Access Compliance Report

Public Rights-of-Way

(Curb Ramps)

Intersection ID: 53488	Main Street: WAVERLY_WALK_AV	Cross Street: MATTHEWS_FARM_LN	Location: SW
ADA ID: 4B28E78D0E5A	Ramp Type: Perp	Initial Pass/Fail: Fail	Overall Compliance: No
Severity Score: 13.75			
Codes/Mitigation Info/Possible Solution		Field Measurements/Component Compliance

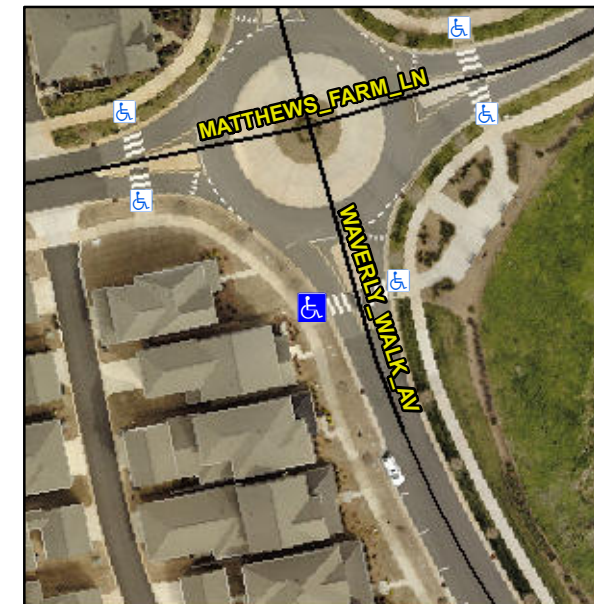
Not Found, R304.2.2, R304.5.3

Compliance	Description	Data	Compliance	Description	Data
N/A	Ramp Length (in)	95.0	No	Ramp Slope (%)	8.9
Yes	Ramp Width (in)	114.0	No	Ramp XSlope (%)	2.6
N/A	Flare Type LT	N/A	N/A	Flare Type RT	N/A
N/A	Flare Slope LT (%)	N/A	N/A	Flare Slope RT (%)	N/A
N/A	Flare Traversable LT?	N/A	N/A	Flare Traversable RT?	N/A
N/A	Landing Length (in)	N/A	N/A	DWS Provided?	N/A
N/A	Landing Width (in)	N/A	N/A	DWS Contrast?	N/A
N/A	Landing Slope (%)	N/A	N/A	DWS Length (in)	N/A
N/A	Landing X Slope (%)	N/A	N/A	DWS Full Width?	N/A
N/A	Landing Curb? (Y/N)	N/A	N/A	DWS Offset (in)	N/A
N/A	Shared Landing?	N/A			
N/A	Gutter Ponding?	N/A	N/A	Gutter Slope (%)	N/A
N/A	Gutter Lip Ht (in)	N/A	N/A	Gutter X Slope (%)	N/A
N/A	Painted X Walk1?	Yes	N/A	Painted X Walk2?	N/A
	X Walk 1 Direction	To E		X Walk 2 Direction	N/A
N/A	X Walk 1 Width (in)	121.0	N/A	X Walk 2 Width (in)	N/A
	X Walk 1 Slope (%)	3.1		X Walk 2 Slope (%)	N/A
	X Walk 1 X Slope (%)	3.9		X Walk 2 X Slope (%)	N/A

Remove & Replace Entire Ramp.
